***Re: Howard Terminal Draft Environmental Impact Report
Comments (Union Pacific Railroad Company)
Case File No.: ER18-016***

To: Peggy Ygbuhay, UPRR
From: Karen Hankinson, PE, TE
Subject: Waterfront Ballpark District at Howard Terminal
Draft Environmental Impact Report Review
Date: April 27, 2021

Per Union Pacific Railroad's request, RailPros has reviewed Chapter 4.15: Transportation and Circulation, and Chapter 6: Alternatives, of the Waterfront Ballpark District at Howard Terminal Draft Environmental Impact Report (DEIR), which was released for public comment on February 26, 2021. Chapter 4.15 evaluates the transportation-related impacts resulting from the proposed Howard Terminal Ballpark development. Chapter 6 evaluates other alternatives that were studied as part of the environmental process. Additional transportation reference materials were released for review by the City of Oakland on March 26, 2021. RailPros has also reviewed the relevant documents from those reference materials which include the Oakland A's Howard Terminal Project Railroad Corridor and Grade Crossing Improvements study, referred to as the "Railroad Study" in the DEIR, the Howard Terminal – Collision Hi

Oakland, CA - Train Occupancies Between Market and MLK at Control Point N1006 - Oakland South

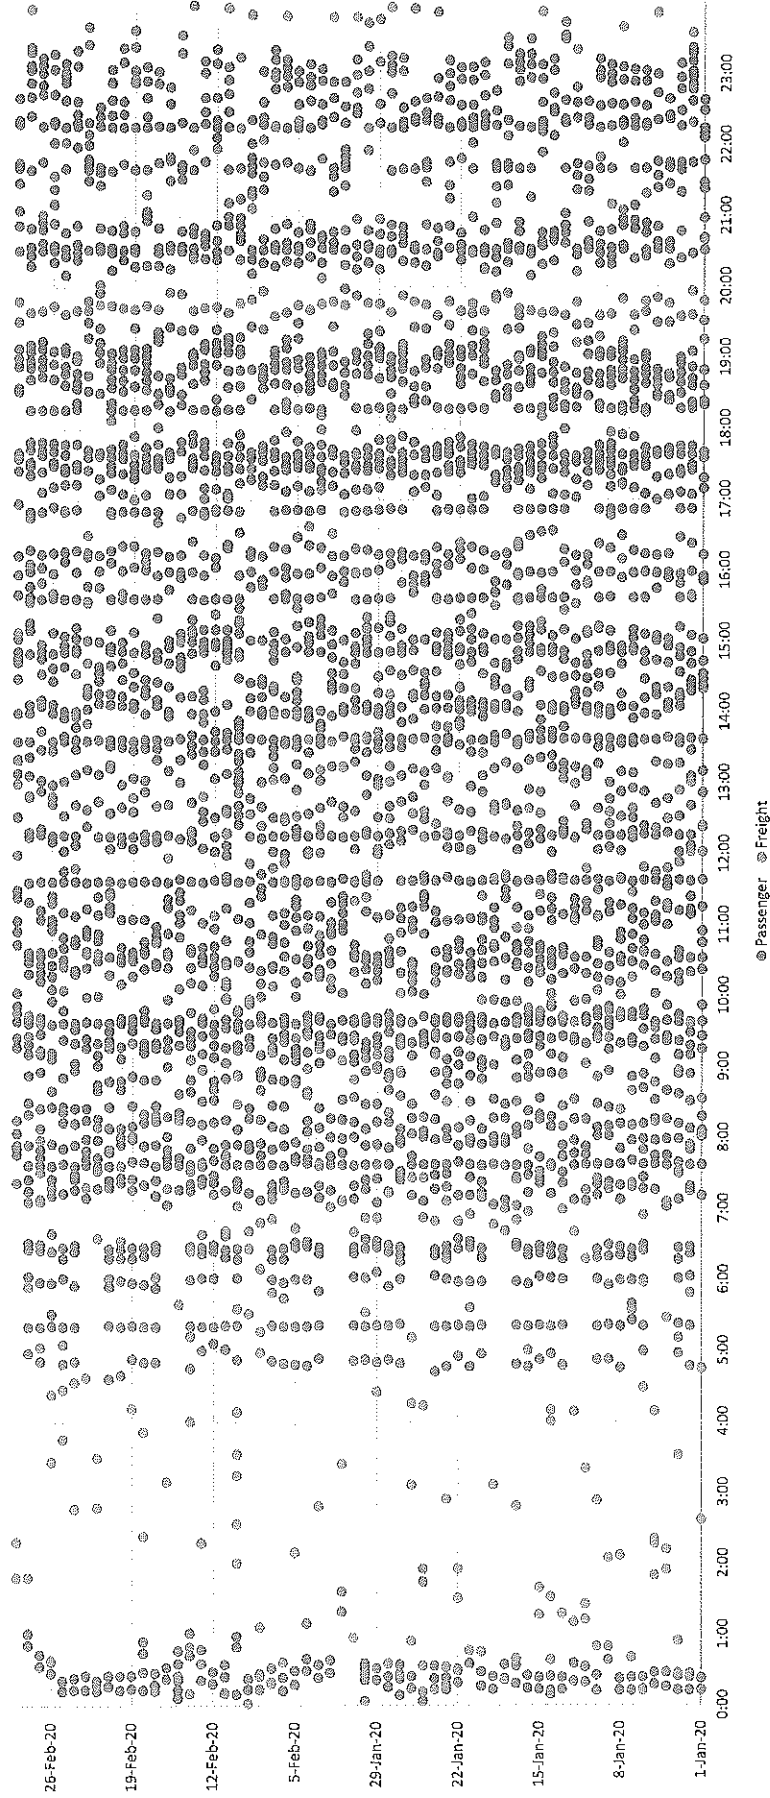
Attached as Exhibit 2 to this comment letter is an hour-by-hour scatter plot of UP's signal activation data depicting both UP freight trains (orange dots) and passenger trains (blue dots) occupying Embarcadero West intersections between Market Street and Martin Luther King Jr. Way during the two month period January 1 to February 29, 2020. Each dot represents a train. Of particular note is not simply the sheer number of trains occupying these intersections throughout each day, but also the unpredictable, complex, and dynamic nature of UP's freight train movements and operations which have no discernable pattern. The DEIR presents a far different picture of predictable and static freight train operations having minimal impact on vehicle traffic and vehicle and pedestrian safety. As Exhibit 2 so vividly demonstrates, nothing could be further from the truth. Trains – usually multiple trains -- occupy these intersections literally during every hour of every day.
